Department of Planning, Housing and Infrastructure

Riverstone East – Stage 3 Finalisation Report

May 2025

Figure 2: Exhibited draft ILP – Riverstone East Stage 3

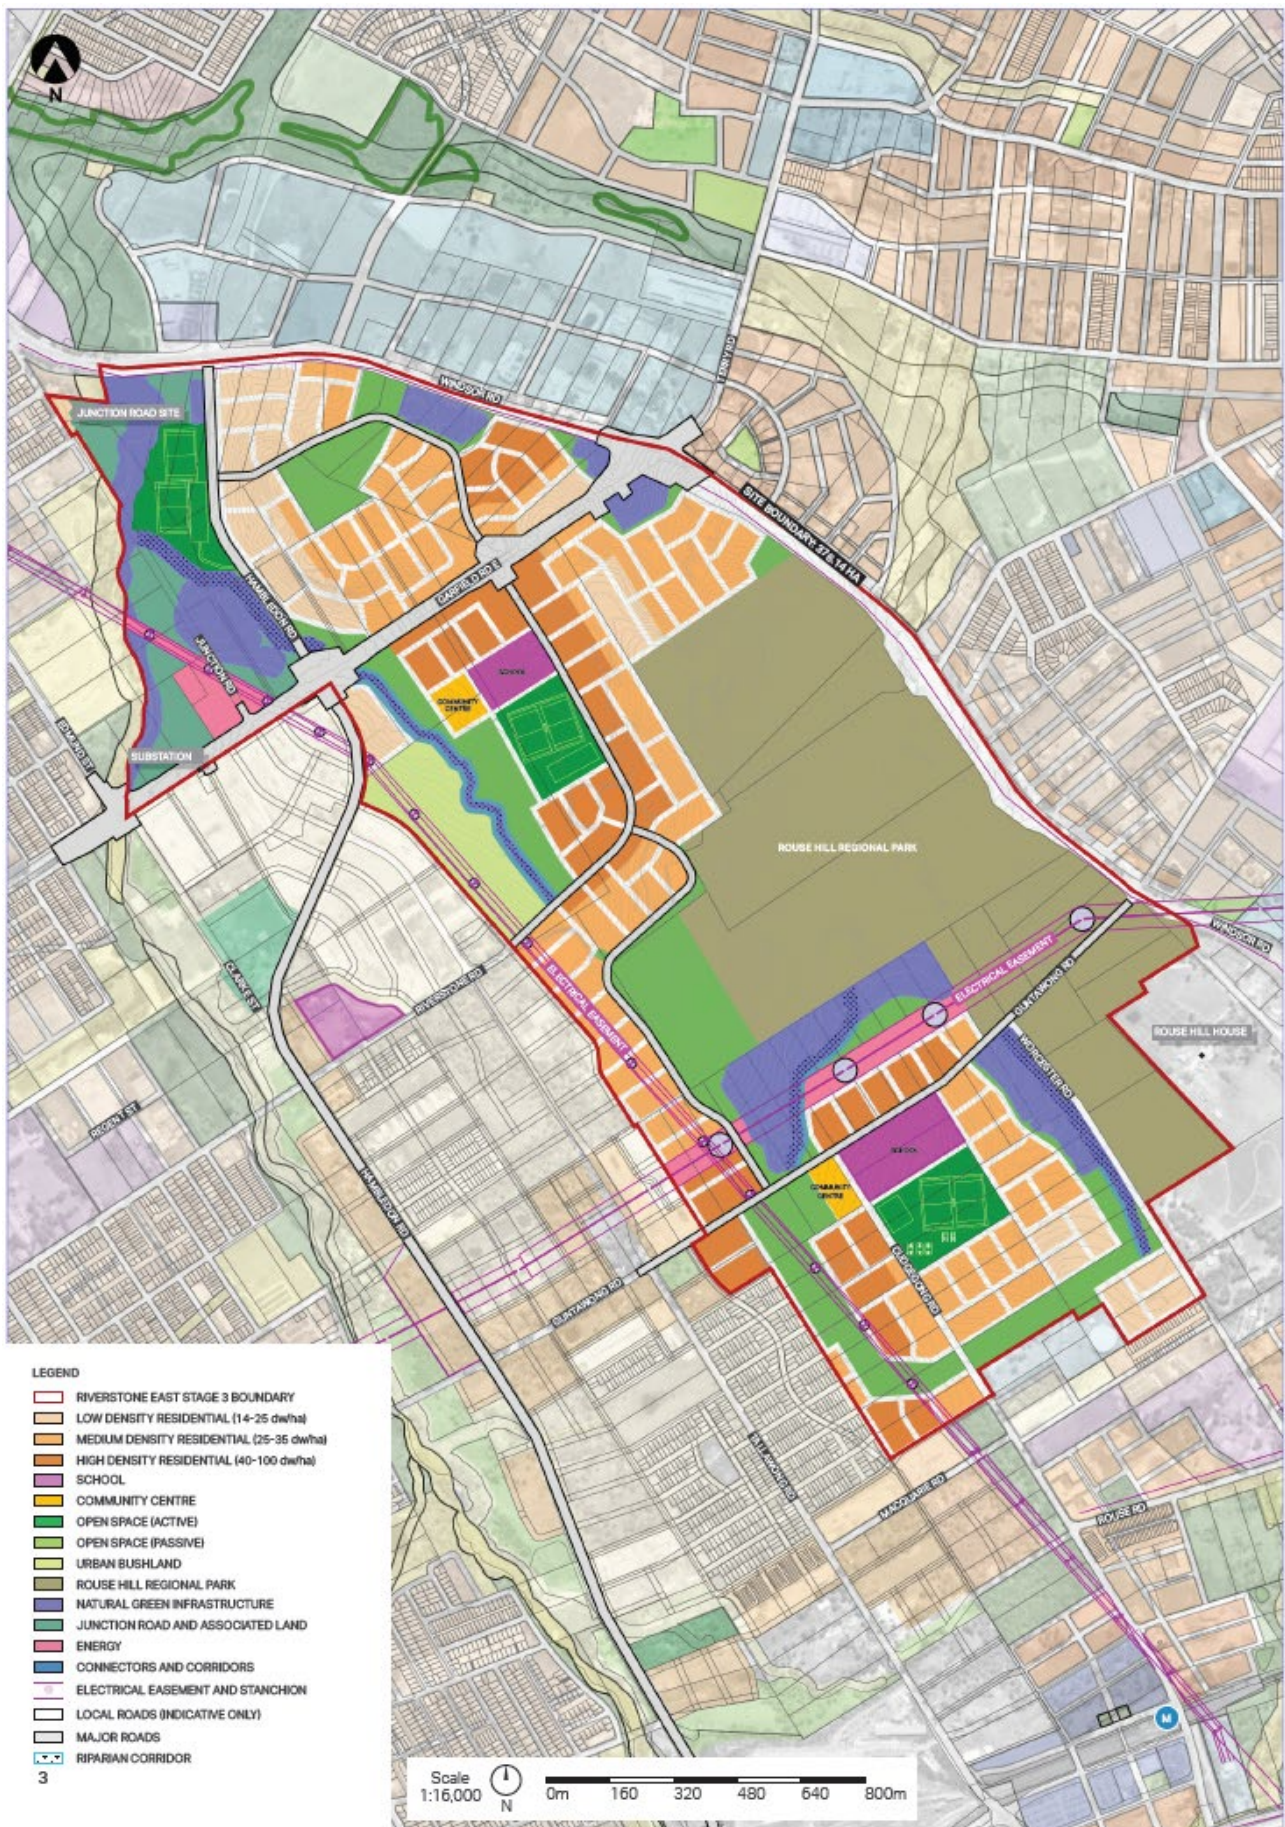
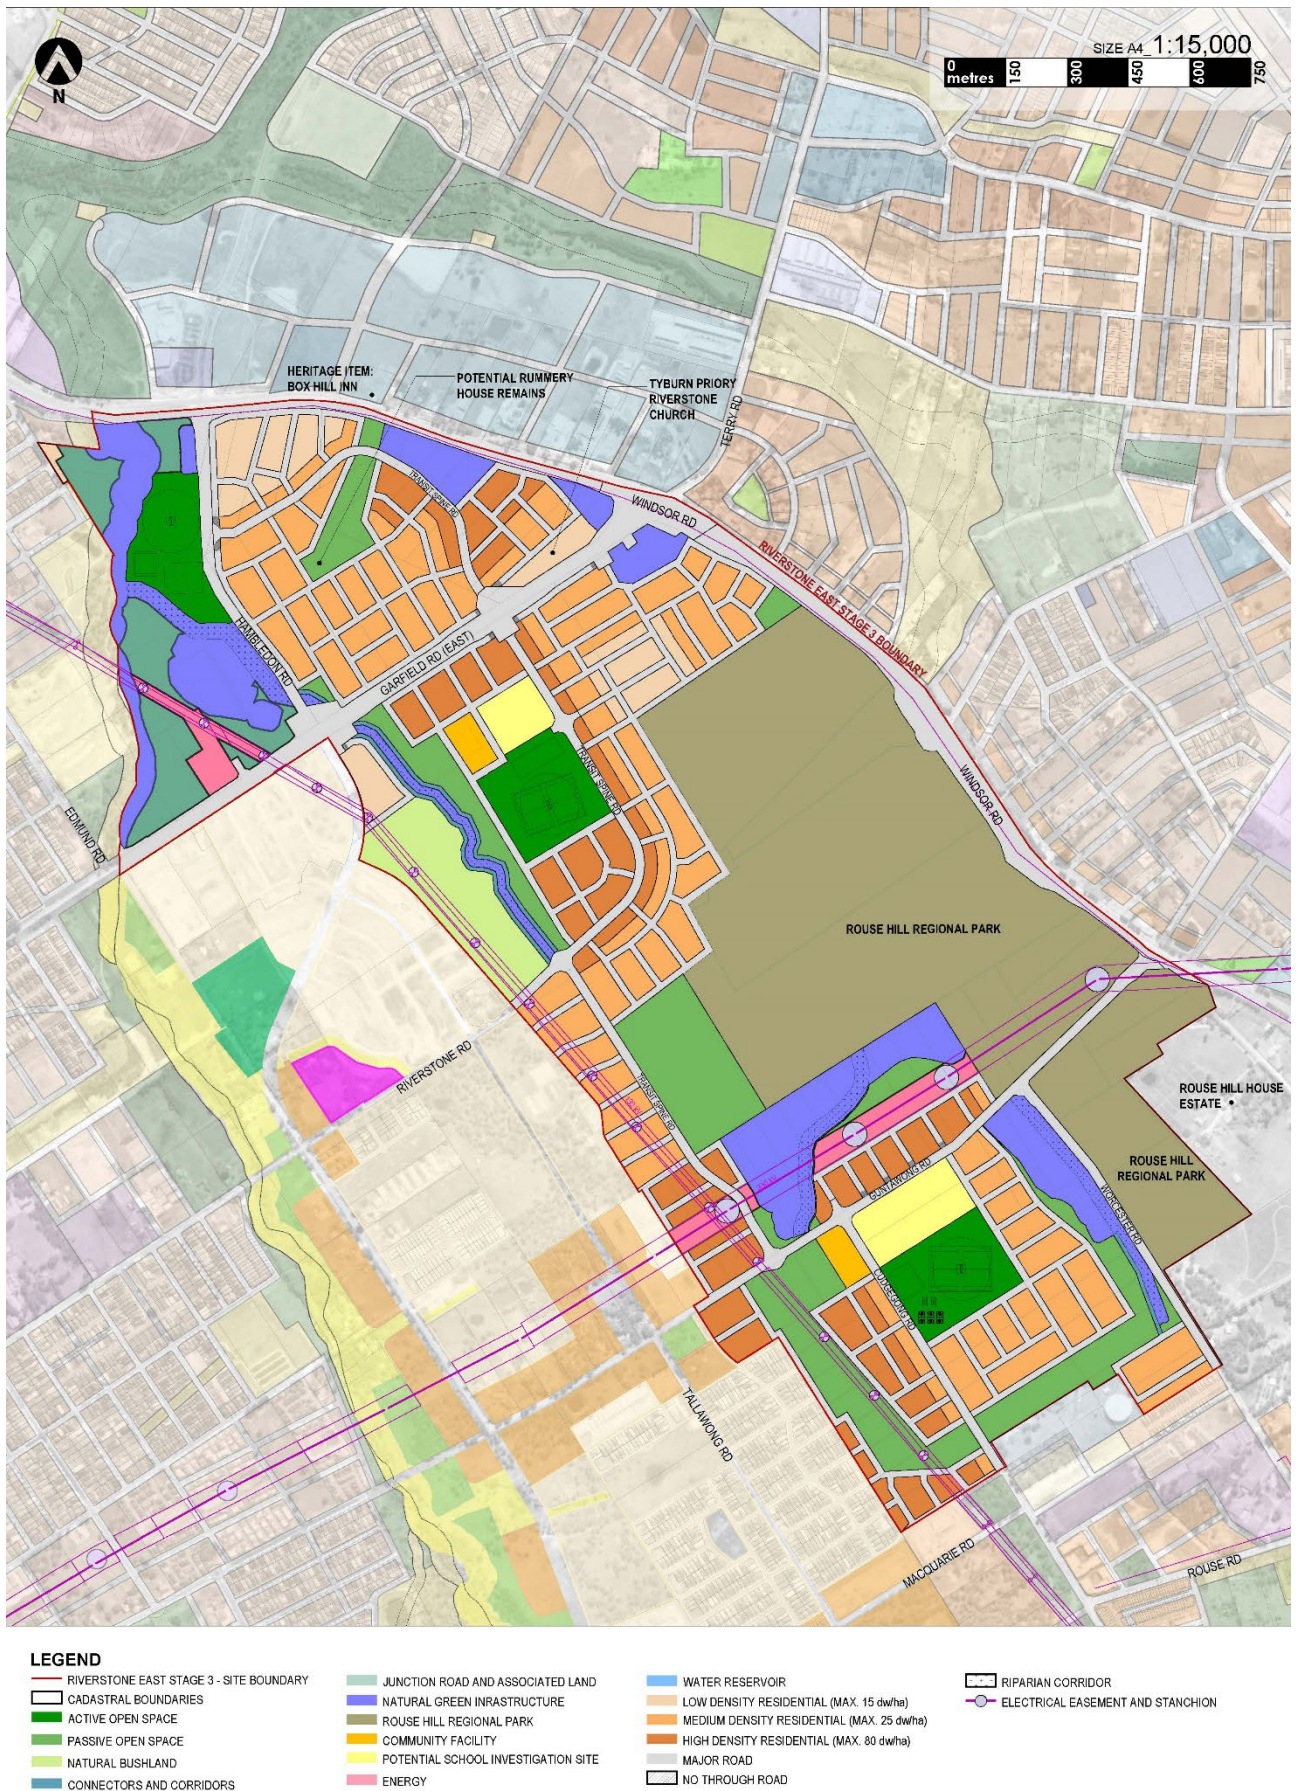
The exhibited ILP and final ILP are shown at **Figure 2** and **Figure 3**. The main planning outcomes of the final ILP are summarised in **Table 1**. Amendments within the adjacent Riverstone East Stage 2 Precinct and the Riverstone Precinct are also required. These amendments are detailed in **Section 6**.

Figure 3: Final ILP – Riverstone East Stage 3

Figure 6: Location of larger lot, low-density homes within the Precinct as exhibited

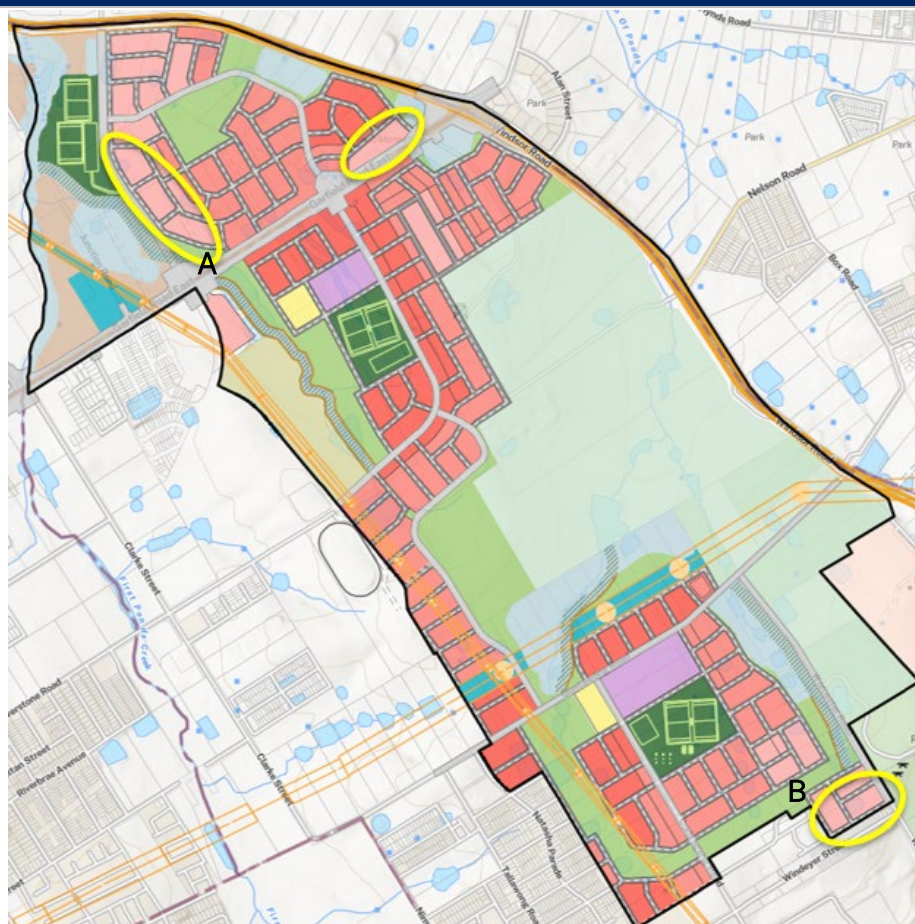
Issue raised	Department response
Land use densities and concerns regarding larger lots	<p>The draft ILP included provision for larger lots up to a maximum of 14 – 17 dwellings per hectare alongside creeks in the northwest and southeast of the Precinct, as well as at the Tyburn Priory (325 Garfield Road East). Refer to areas marked ‘A’ and ‘B’ on Figure 6.</p> <p>Submissions raised concerns about the feasibility and affordability of larger lots, technical advice highlighted a preference for smaller housing typologies due to affordability considerations. It is important to note that no submissions were received from known First Nations stakeholders during the exhibition period.</p> <p>In response to these concerns, the density of the lots has been adjusted to provide more homes on these sites, aligning with adjoining densities. This approach ensures the delivery of appropriate densities and lot sizes that are feasible and respond to the need for affordable housing. The ultimate housing yield remains approximately 3,600 homes.</p> <p>Additionally, the Department received submissions requesting an extension of residential zoning along the precinct's southwest boundary to improve the residential interface with Stage 1. However, post-exhibition analysis confirmed this area is within the flood planning area and cannot support residential development. Consequently, this land will form part of the open space network, which is suitable for flood-prone areas.</p>

Objection Density zone	R4 High Residential	R4 High Density zone has been deleted from the plan in response to concerns raised by Council. The R3 Medium Density residential zone is sufficient to permit residential flat buildings across the Precinct, with differing heights to be controlled through the height of building map in Central River City SEPP. This has not resulted in a loss of homes in the Precinct. Corresponding zoning changes are reflected on the land zoning map. The ultimate housing yield remains at approximately 3,600 homes.
Update of maximum density controls		<p>The maximum densities for development relative to land use zoned in the Precinct have been rationalised to simplify the controls to meet the vision for the Precinct and support a diverse range of housing types whilst not compromising overall precinct yield for new homes – refer to Table 4.</p> <p>The redistribution of dwelling density bands ensures consistency with the existing Precincts—Central River City SEPP regulations. This alignment helps maintain uniformity across different precincts within the NWGA,</p>

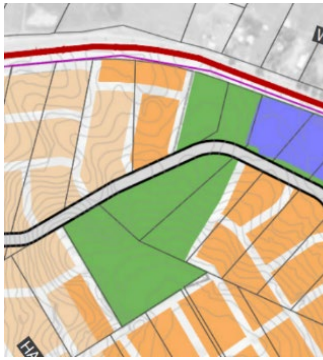
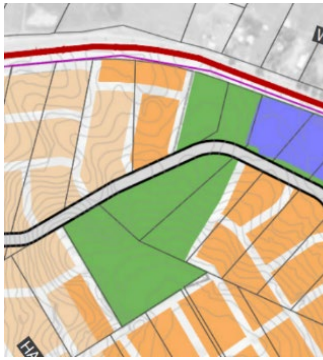
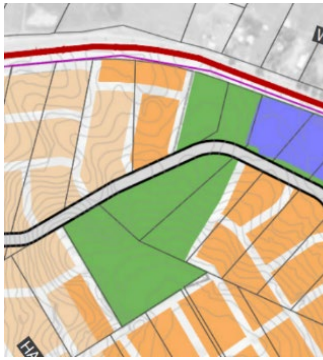
Issue raised	Department response				
<p>Evidence to verify Rummary House remains and impacts on potential residential development</p>	<p>Submissions raised concerns with the proposed heritage listing of the Potential Rummary House archaeological remains under the SEPP and the perceived lack of evidence to support that listing. The archaeological potential could not be verified during the planning phase.</p> <p>The proposed open space on part of Lot 23 DP 30458 will serve to portion the site where remains have the potential to be present and maintain a view corridor to Box Hill Inn. The balance of the site is considered appropriate for development as shown in Figure 10 subject to development applications supported by an archaeological assessment, as required by the DCP.</p> <p>Figure 10: Exhibited and final ILP for Rummary House open space extent</p> <table border="1"> <thead> <tr> <th data-bbox="486 741 820 826">Exhibited draft ILP</th><th data-bbox="820 741 1153 826">Final ILP</th></tr> </thead> <tbody> <tr> <td data-bbox="486 826 820 1335">  <p>Exhibited draft ILP and extent of open space</p> </td><td data-bbox="820 826 1153 1335">  <p>Final ILP with refined extent of open space</p> </td></tr> </tbody> </table>	Exhibited draft ILP	Final ILP	 <p>Exhibited draft ILP and extent of open space</p>	 <p>Final ILP with refined extent of open space</p>
Exhibited draft ILP	Final ILP				
 <p>Exhibited draft ILP and extent of open space</p>	 <p>Final ILP with refined extent of open space</p>

Figure 11 - Precinct street hierarchy plan

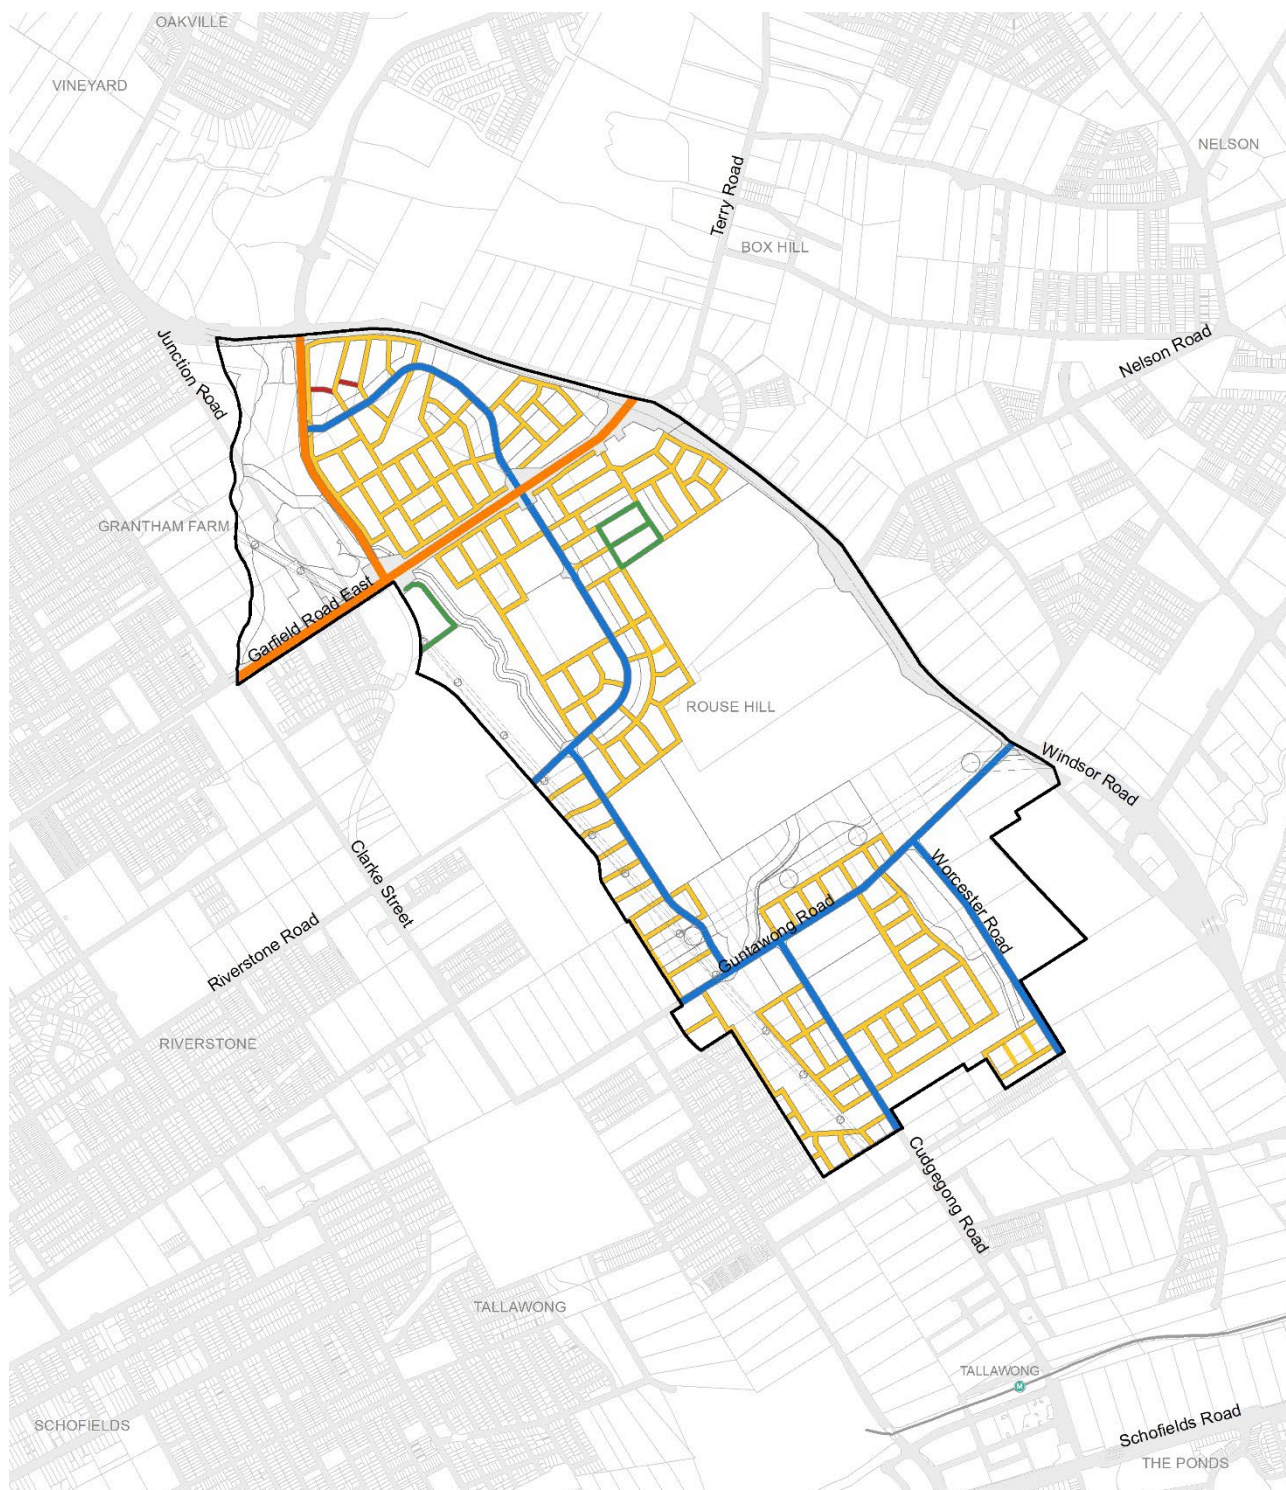
In response to issues raised in Council's submission, including reducing urban heat and increasing sustainability outcomes, the WSSDG have been integrated into the final precinct planning package. The WSSDG seek to reverse design changes within the development of suburban streets that enabled them to become less attractive, hotter, dominated by cars and less environmentally sustainable. The key advantages of utilising the WSSDG within the Precinct include:

Following review by technical specialists and further consultation with Council, the total street reservation width of Residential Ways has increased from 14 metres in Council’s submission to 16 metres to align with Yield Streets. This increase in the total street reservation provides consistency and enables additional area for unobstructed utility trenches and footpaths on one side. Residential Ways and Yield Streets will only be utilised in the R2 – Low-Density residential areas.

The updated street hierarchy to be adopted for the Precinct is shown in **Figure 11**.
